UNITED STATES PATENT AND TRADEMARK OFFICE

APPLICATION NO.	FILING DATE	FIRST NAMED INVENTOR	ATTORNEY DOCKET NO.	CONFIRMATION NO.
09/864,389	05/25/2001	Jacob Richter	2390/49704	1194

# Office Action Summary

FIG. 1

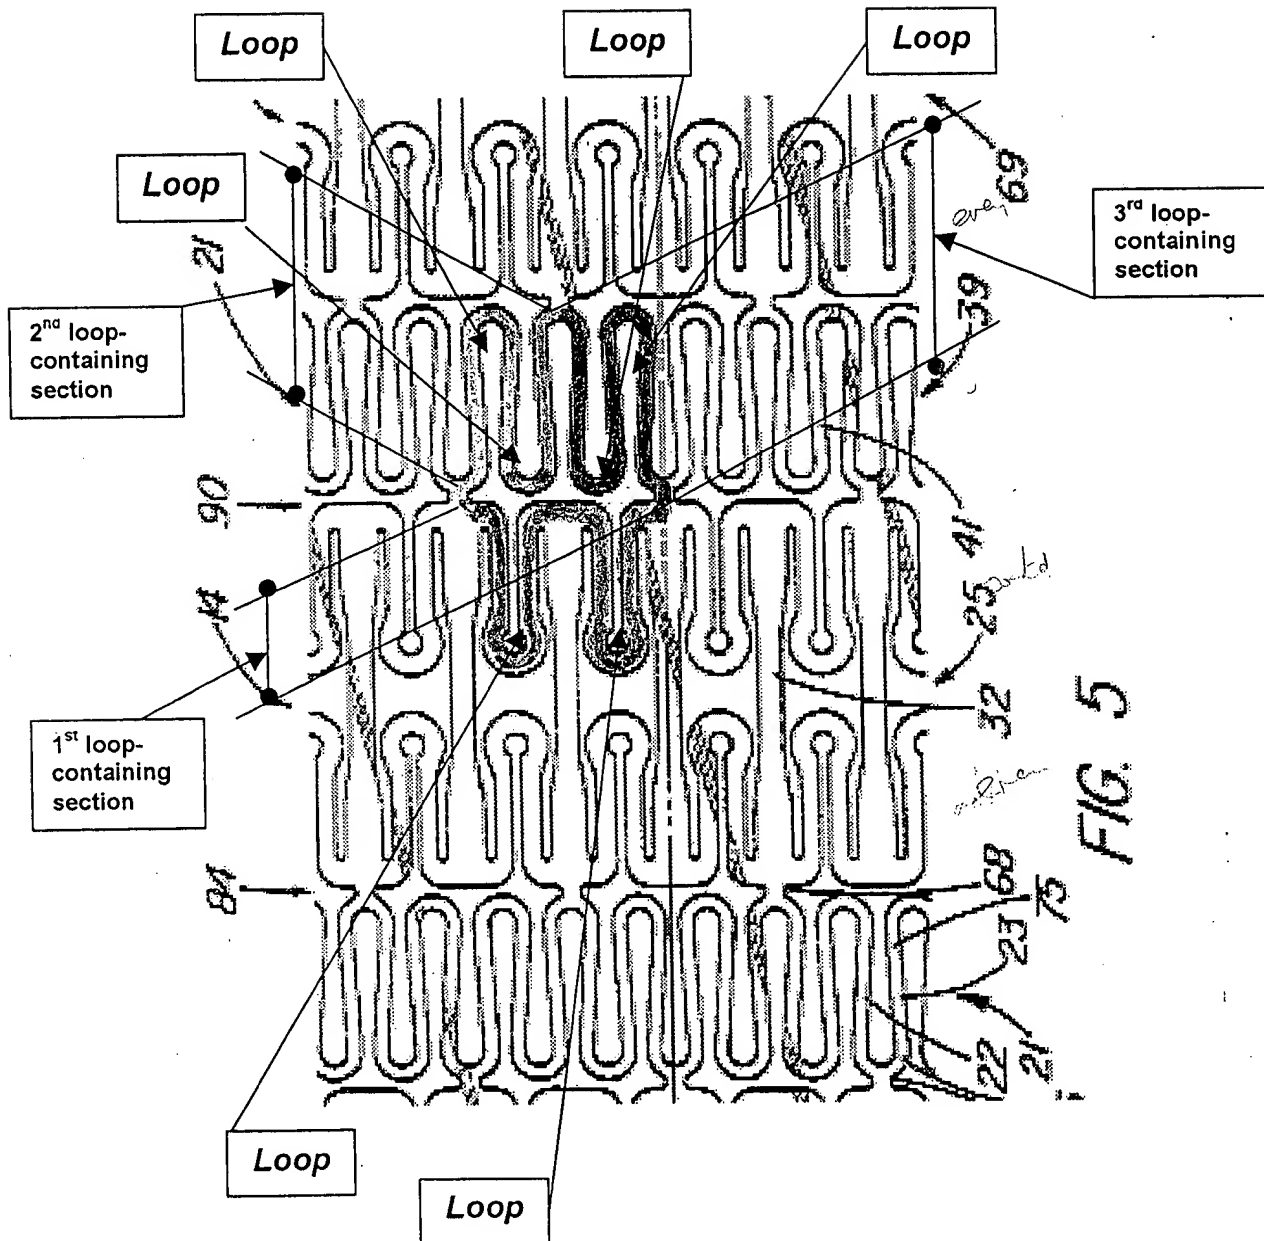
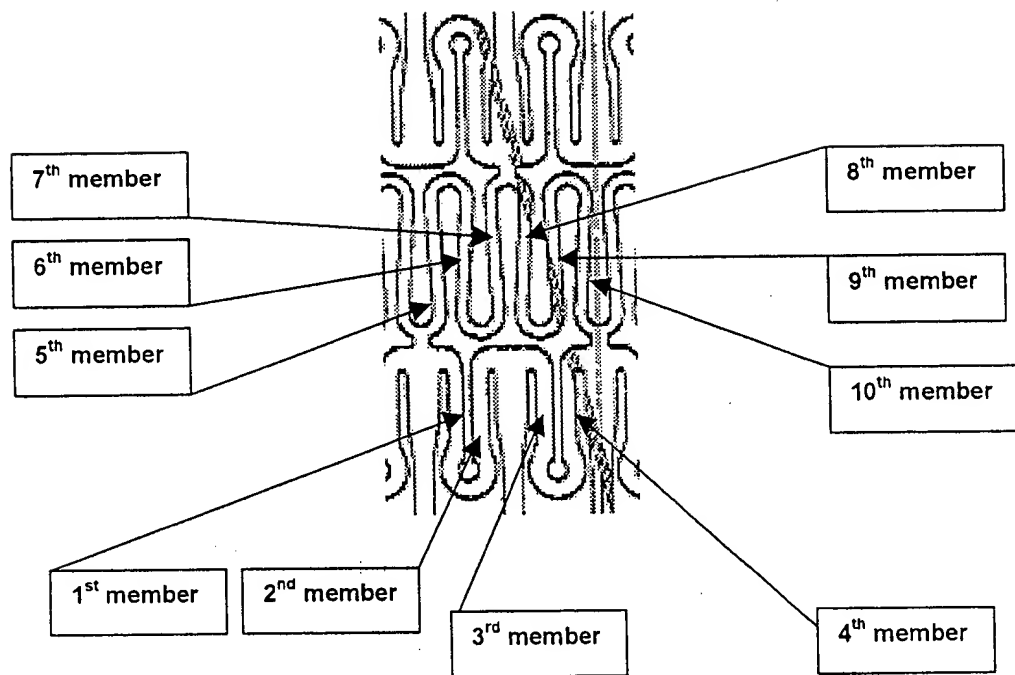
As to claims 1 and 6, BERRY (Fig. 5, also Fig. 1, this paper) discloses a stent having first loop containing sections/first circumferential bands of loops at a first frequency, second loop containing sections/first circumferential bands of loops of said first frequency, and third loop containing sections/second circumferential bands of loops of a second frequency disposed between the first and second loop containing sections. The second frequency is higher than the first frequency. The first or second loop containing sections/the first circumferential bands and the third loop containing sections/the second circumferential bands define cells (yellow color, Fig. 5 and Fig. 1, this paper). Notice that because the 5<sup>th</sup>, 6<sup>th</sup>, 7<sup>th</sup>, 8<sup>th</sup>, 9<sup>th</sup> and 10<sup>th</sup> members shown in Fig. 1 of the third loop containing sections/second circumferential bands are more flexible than the 1<sup>st</sup>, 2<sup>nd</sup>, 3<sup>rd</sup>, 4<sup>th</sup> members, the 5<sup>th</sup>, 6<sup>th</sup>, 7<sup>th</sup>, 8<sup>th</sup>, 9<sup>th</sup> and 10<sup>th</sup> members of the third loop containing sections/second circumferential bands of the second (higher) frequency contribute most of the stent cells' elongation or shortening, and therefore contribute most of the deformation during flexing of the stent.

As to claim 42, BERRY (Fig. 1 and 5, this paper) shows the loops in the first and second loop containing sections are 180 degrees out of phase.

As to claims 2, 4, 7, 9, 43 and 44, BERRY stent of stainless steel (BERRY, column 8, lines 37-40) has cells formed by the 1<sup>st</sup> to 10<sup>th</sup> members (see Fig. 1 and 5, this paper). Notice that the third loop containing sections/second circumferential bands of BERRY stent is shaped in a sinuous pattern which has a longer longitudinal length in an unexpanded configuration wherein the 5<sup>th</sup> to 10<sup>th</sup> members are closer one to another and a shorter longitudinal length in an expanded configuration wherein the 5<sup>th</sup> to 10<sup>th</sup> members are farther apart one to another. Each cell defines a closed radial opening surrounded by the 1<sup>st</sup> to 10<sup>th</sup> members and each cell will expand in a circumferential direction when the cell is compressed in a longitudinal direction, or each cell will expand in the longitudinal direction when the cell is compressed in the circumferential direction. Therefore, in a straight portion of a curved blood vessel, BERRY stent will provide cells open in length but narrow circumferentially, and in a curved portion of the vessel, some of the cells will be bent and shortened in longitudinal length but widen circumferentially to result in a more constant density of stent element area between the inside and the outside of the curved portion of the vessel or to result in a more constant stent cell area between the inside and the outside of the curved portion of the vessel.

As to claims 11-12, and 14, BERRY (Fig. 1 and 5, this paper) discloses a stent having triangular cells defined by a 1<sup>st</sup> loop-containing section (colored in brown), a 2<sup>nd</sup> loop-containing section (green) and a 3<sup>rd</sup> loop-containing section (purple). The 1<sup>st</sup>, 2<sup>nd</sup> and 3<sup>rd</sup> loop-containing sections form a triangular cell (colored in yellow). The 1<sup>st</sup> junction point joins the 1<sup>st</sup> and the 2<sup>nd</sup> loop containing sections, 2<sup>nd</sup> junction point joins the 1<sup>st</sup> and the 3<sup>rd</sup> loop containing sections, and 3<sup>rd</sup> junction point joins the 2<sup>nd</sup> and the 3<sup>rd</sup> loop containing sections as recited in the claims. Notice that the 2<sup>nd</sup> and 3<sup>rd</sup> loop containing sections of BERRY stent are shaped in a sinuous pattern of adjacent struts to define cells (colored in yellow). For the same reason mentioned earlier, in a straight portion of a curved blood vessel, BERRY stent will provide cells open in length but narrow circumferentially, and in a curved portion of the vessel, some of the cells will be bent and shortened in longitudinal length but widen circumferentially to result in a more

As to claims 16-17, 19, 21-22, and 24, BERRY (Fig. 1 and 5, this paper) discloses vertical (odd and even) meander/first meander patterns (highlighted in red) intertwine horizontal meander/second meander pattern (in green) to form cells (colored in yellow). Notice that the vertical (even) meander/first meander patterns of BERRY stent are shaped in a sinuous pattern of circumferentially adjacent struts which have a longer longitudinal length in an unexpanded configuration where the adjacent struts are closer one to another and a shorter longitudinal length in an expanded configuration where the adjacent struts are farther apart one to another. The meander patterns intertwine and define cells. For the same reason mentioned earlier, in a straight portion of a curved blood vessel, BERRY stent will provide cells open in length but narrow circumferentially, and in a curved portion of the vessel, some of the cells will be bent and shortened in longitudinal length but widen circumferentially to result in a more constant density of stent element area between the inside and the outside of the curved portion of the vessel or to result in a more constant stent cell area between the inside and the outside of the curved portion of the vessel.

As to claims 26-27 and 29, BERRY (Fig. 1 and 5, this paper) discloses stent of stainless steel having 1<sup>st</sup>, 2<sup>nd</sup>, 3<sup>rd</sup>, 4<sup>th</sup>, 5<sup>th</sup>, 6<sup>th</sup>, 7<sup>th</sup>, 8<sup>th</sup>, 9<sup>th</sup>, and 10<sup>th</sup> members which are interconnected as recited in the claims. The curved junction portions of the members define 1<sup>st</sup>, 2<sup>nd</sup>, 3<sup>rd</sup>, 4<sup>th</sup>, and 5<sup>th</sup> loops as recited in the claims. The 1st to 10th members define a cell. Each cell defines a closed radial opening surrounded by the 1st to 10th members. For the same reason mentioned earlier, in a straight portion of a curved blood vessel, BERRY stent will provide cells open in length but narrow circumferentially, and in a curved portion of the vessel, some of the cells will be bent and shortened in longitudinal length but widen circumferentially to result in a more constant density of stent element area between the inside and the outside of the curved portion of the vessel or to result in a more constant stent cell area between the inside and the outside of the curved portion of the vessel.
